STAFF REPORT: JULY 12, 2023 MEETING

APPLICATION NUMBER: 23-8442

ADDRESS: 1419 SEYBURN

SCOPE: REHABILITATE DWELLING, REPLACE WINDOWS

North-Side Elevation

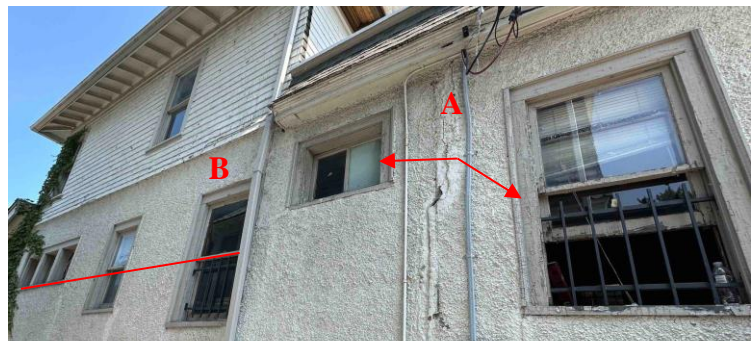
- A. Remove small sliding and double-hung windows. Enclose openings and apply stucco finish.
- B. Remove window and enclose bottom half of opening. Apply stucco finish. Sill height to match adjacent windows near front of house.

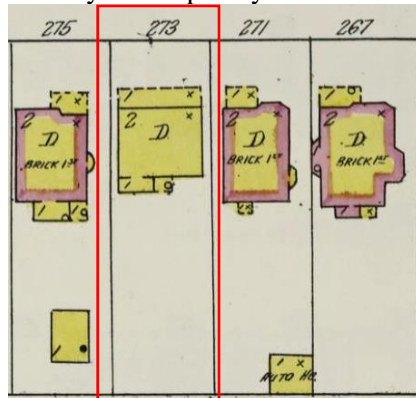
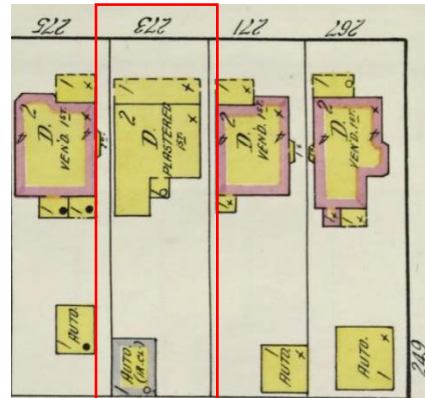
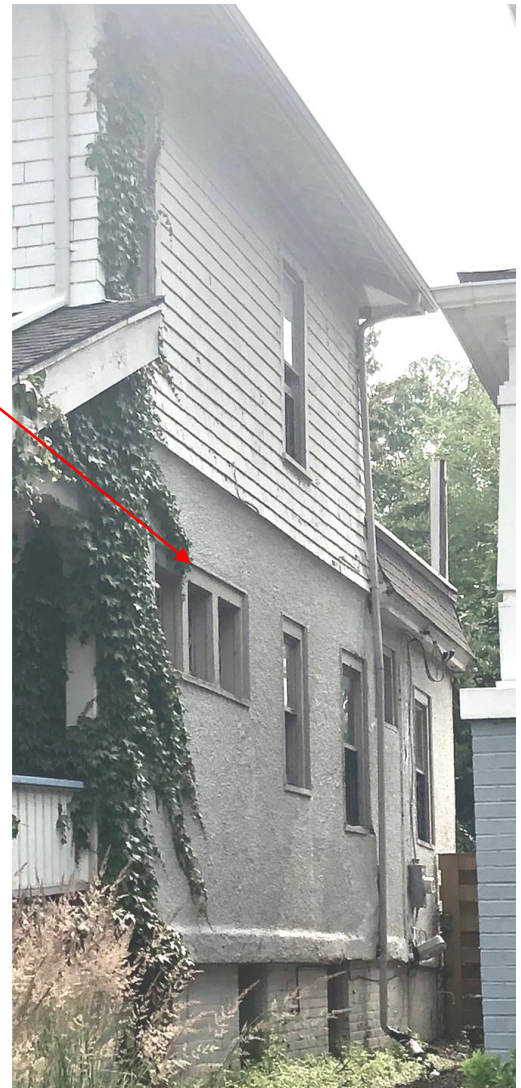
- As staff illustrated in a previous report for 7908 St. Paul (03/08/23 meeting), between 1910 and 1915, a large number of houses within West Village underwent renovation. Changes documented on Sanborn maps included buildings and/or porches being enlarged, and bay windows added.
 - The historical study at 1419 Seyburn shows it was enlarged at the rear, which remains its current footprint.
 - The yellow color denotes a wood frame/wood sided structure. By 1915, the note “Plastered 1st” was added to indicate stucco had been applied to the first floor exterior walls. Staff assumes the stucco was applied over the wood siding, as the first floor window openings have wood casings which are now recessed within the stucco walls.

- While the rear extension and retention of a small portion of the 1910 narrow wood porch is documented in the 1915 Sanborn map, it is staff's opinion that these areas of the structure are not distinctive character-defining features of the property. Therefore, staff believes the proposed alterations to these wall surfaces will not alter features and spaces that characterize the property.

1983 Designation photo, HDAB. Wing walls that were removed without Commission approval.

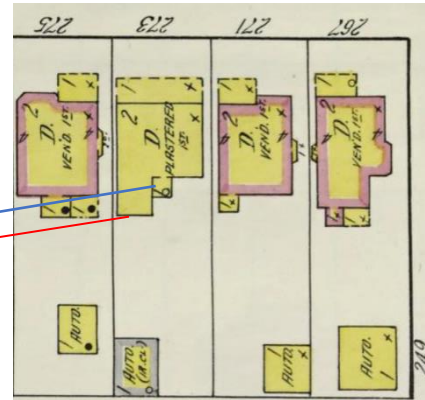
- Comparing existing conditions of the front porch to that captured in the designation photo, confirms much of the existing porch structure and detailing is original and/or historic. However, some changes have occurred without Commission approval, including a replacement porch railing and the removal of the front steps wing walls, both of which are distinctive character-defining features. A 2000 violation notice was found in the property file, but no documentation on further enforcement was located.

- The wing walls were an effective way to enclose the stairs in lieu of a railing. Prior to designation, pipe railings at the stairs and front walk were installed. It is staff's opinion the pipe railings are not historic nor appropriate for the property. As the wing walls were removed decades ago, this is not a current violation and is not addressed within this application.

- The existing railing is sympathetic in styling, height (taller than the historic railing, but likely lower than a contemporary 36-inch railing), material and finish, but doesn't meet Secretary of the Interior Standard 6, which requires exact replacement of deteriorated character-defining features.

Left: Rear, second story window, new bathroom location. Right: Jeld-Wen catalog.

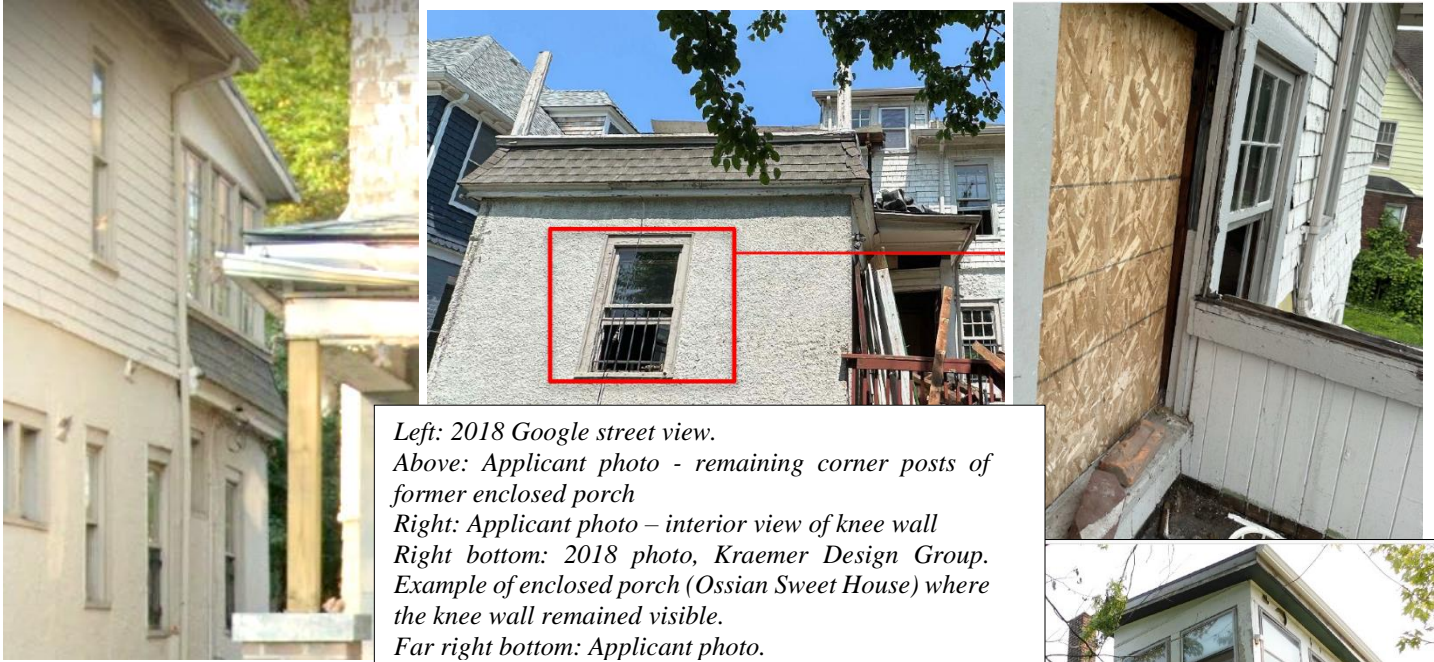
- For the window at the rear elevation shower location, it appears the Marvin Infinity line offers a custom simulated divided-light six-over-one pattern, as well as a "simulated check rail to give the look of a double-hung on a casement window". The applicant specified white opaque glass. Staff assumes this glass would create an opposing contrast of the divided light/check rail pattern than is typical of historic window openings. Should the Commission consider the fiberglass unit at this location, Marvin offers obscure glass. This would retain the typical relationship of darker glass and lighter colored frame while offering privacy at this second story rear elevation location. A dimensioned rendering of the custom window should be submitted before a

final decision is made on this window opening.

- A dimensioned window order showing design/window operation of new large window at rear will be submitted to staff for review.
- Dimensions of existing double-hung window for comparison with proposed replacement window to be installed at empty window openings will be submitted.
